RE: Petition No. 1238: 1779 Line Upgrade Project: 115-kV Transmission Line Rebuild
Request for Construction Modification at Structure 3005 (Town of East Hartford) and Sunday Work Hours (Town of East Hartford and Blue Hills Staging Area, Town of Bloomfield)

Revised Petition Attachment B, Mapsheets 2 and 3

1779 Line Rebuild Project East Hartford & South Windsor Revised Petition Map - DRAFT

Sheet 2 of 11

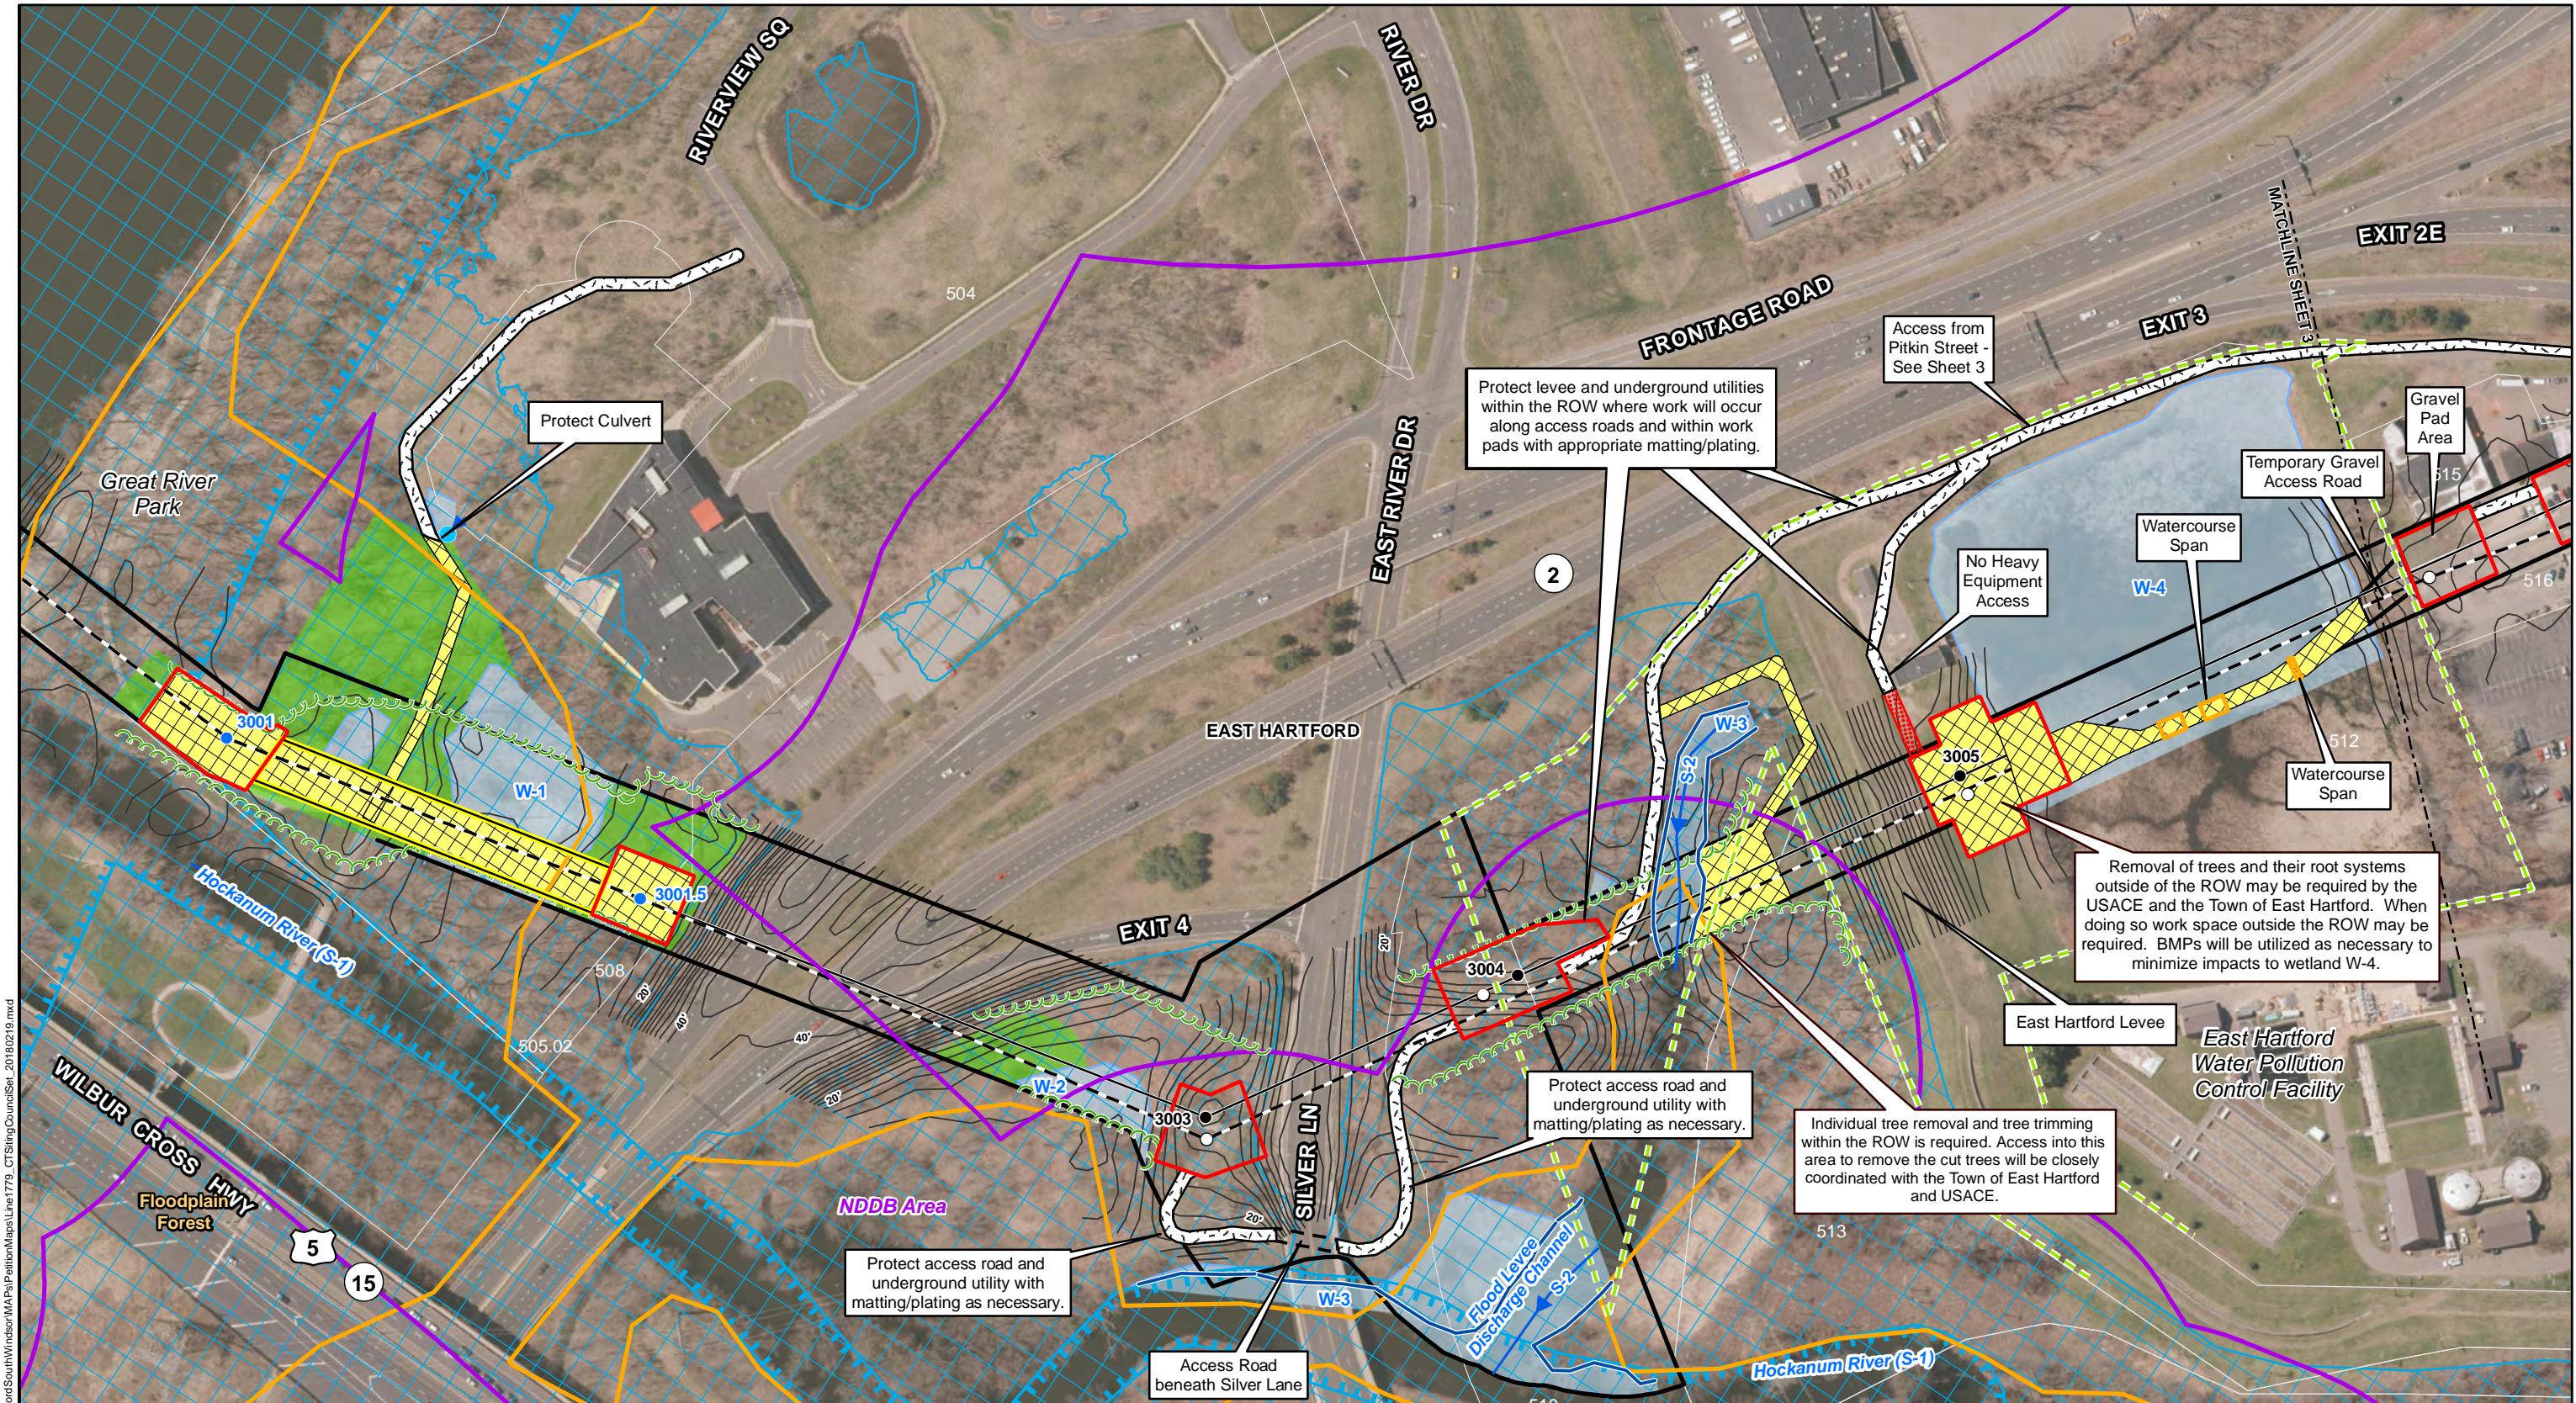
The Project was required to revise the approved access to Structure 3005 by the Metropolitan District Commission (MDC) and Town of East Hartford due to concerns that the heavy construction equipment required to install Structure 3005 would place unacceptably high loads on the underground utilities (e.g., water and sewer lines).

At the direction of the MDC and the Town of East Hartford, Eversource is requesting a new temporary access to cross the Meadow Hill Retention Pond (Pond) to facilitate work activities at Structure 3005. The construction access to be installed will utilize timber matting and include approximately 500 feet in additional access road construction as well as an expansion of the Structure 3005 work pad area. The existing right-of-way from Pitkin street would be the used to access the Pond. See Revised Attachment B: Mapsheets 2 and 3 of 11.

Eversource consulted with the U.S. Army Corps of Engineers (USACE) to revise the Project's Section 408 permit to cross the Pond and provided a plan which has been approved by the USACE and the Town of East Hartford. All work for the proposed temporary access roads and work pads at and south of Structure 3005 will conform to the requirements of the Council's approval of Petition 1238, as well as the requirements of other regulatory approvals for the Project.

Eversource will remove the temporary access and work pads upon completion of the construction for Structure 3005.
